DESIGN ADVISORY BOARD Tuesday, August 25, 2015 at 3:00 PM Conference Room 12, City Hall, Burlington, VT

MEMORANDUM

To: The Design Advisory Board
From: Mary O'Neil, AICP, Senior Planner
RE: 122 Summit Street ZP16-0128CA
Date: August 25, 2015

A-2.1

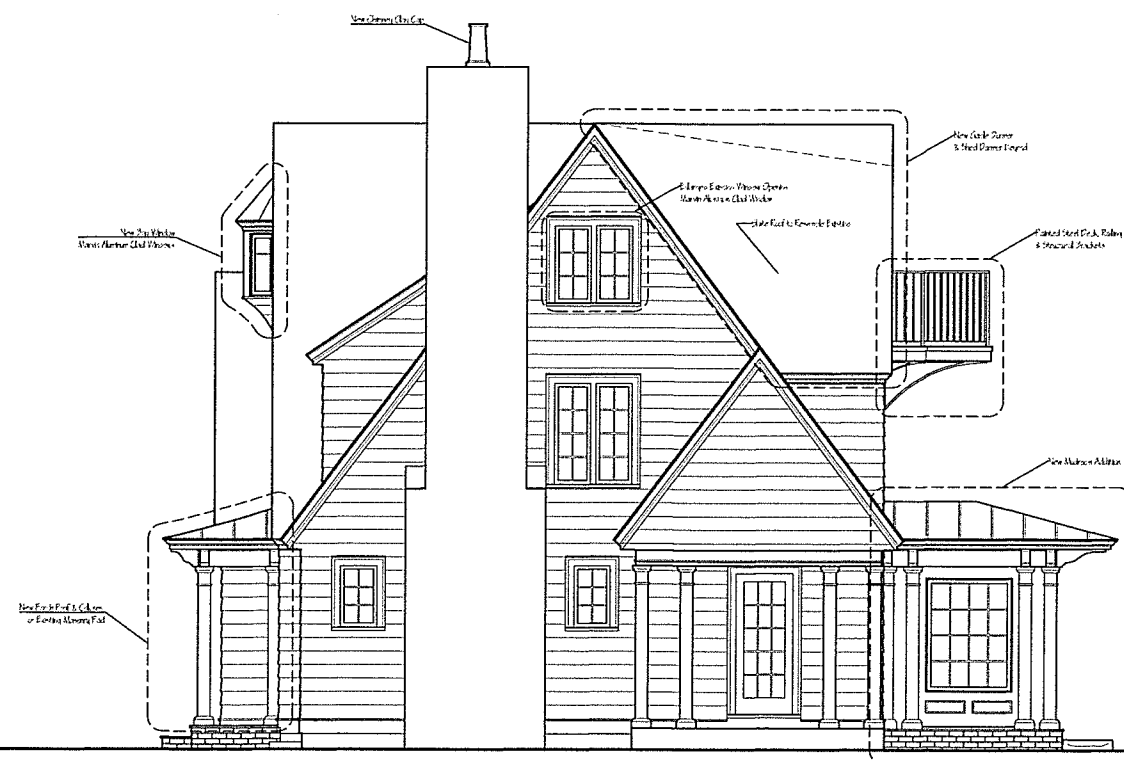
The application proposes replacement of the front door hood with a metal clad shed-roofed canopy, which is not typically associated with either style. See Section 5.4.8.

At question is the proposed alteration of the entrance portico and third story attic window.

styles. The removal of the Colonial door hood and replacement with a more modern shed roof is incongruous in this location.

The third floor window is among one of the truest character defining features of the Tudor style. As the influence was early 16th century English architecture, the small opening references an “arrow loop” or “loophole” for light, air, or shooting weaponry in defense. While first or second floor windows may reflect multi-paned or oriel (projecting) window arrangements, the third floor is most typically the smaller example.

The large third floor bay window is not original to the house, nor was originally proposed in the architectural plans. To add one now is inconsistent with the style and this particular example.

The Colonial entrance portico and the small third story window are both typical and representative characteristics of the blended Tudor/Colonial style at 122 Summit Street, and are recommended for retention.

Motion by Matt Bushey: Regarding 122 Summit Street, the Board feels the property is eligible for historic listing to the Vermont State Register due to its historic integrity and condition per the standards before us. The Board has no objection to changes proposed for the north, south or east elevations. There is no objection to the proposed alteration of the front entry, as has been revised. The proposed bay window at the 3rd floor of the west elevation is not approved; revision with a larger window in the same plane of the house is acceptable.

OPTIONAL BUILDING ELEVATION

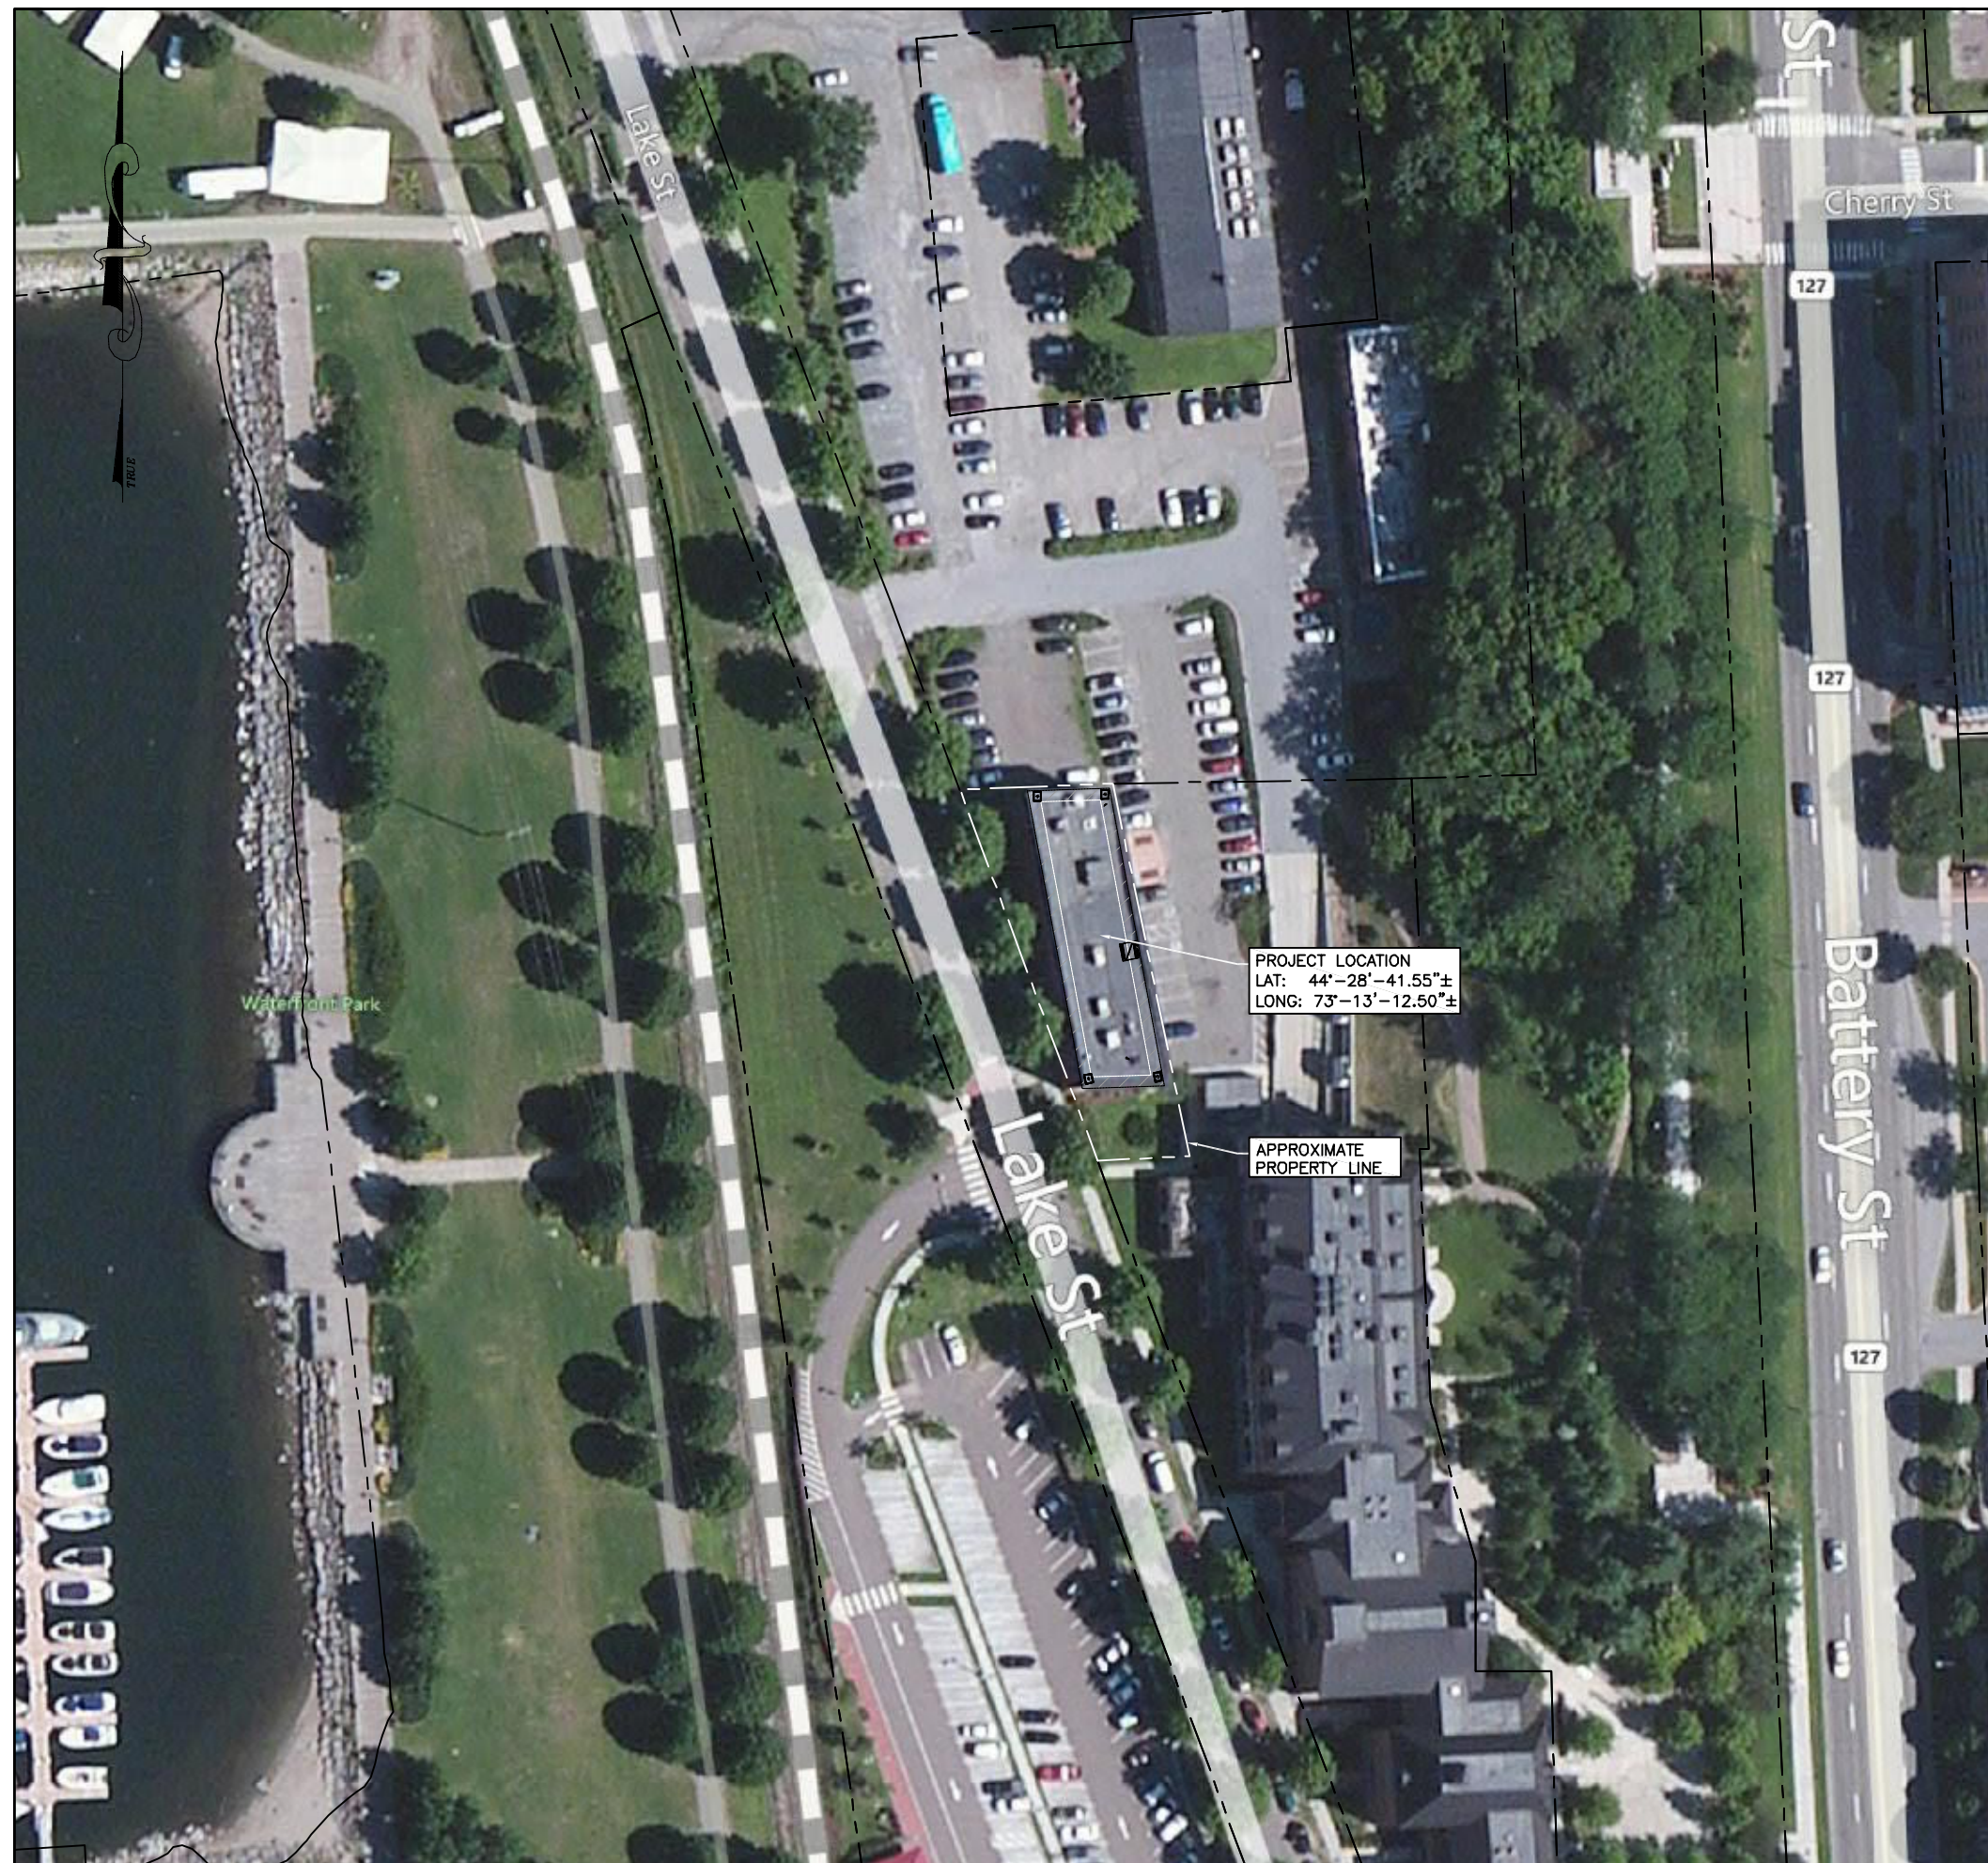
- 10KW generator has been moved from the basement to the area previous designated for an air exchanger on the west (front) side of the property. The equipment does not exceed the size of what was previously submitted for review by the HPRC.

- Exterior conduit on the north side of the building has been removed due to generator relocation.
- Landscaping has been added as an equipment screen on the west elevation per recommendation of the Planning Commission.
- The gas connection on the north elevation is illustrated as protected from vehicular damage by bollards, per recommendation of Planning Commission.

Motion by Matthew Bushey: The Board sees the proposed revisions as minor; no adverse effect. I move we accept the plan as revised.
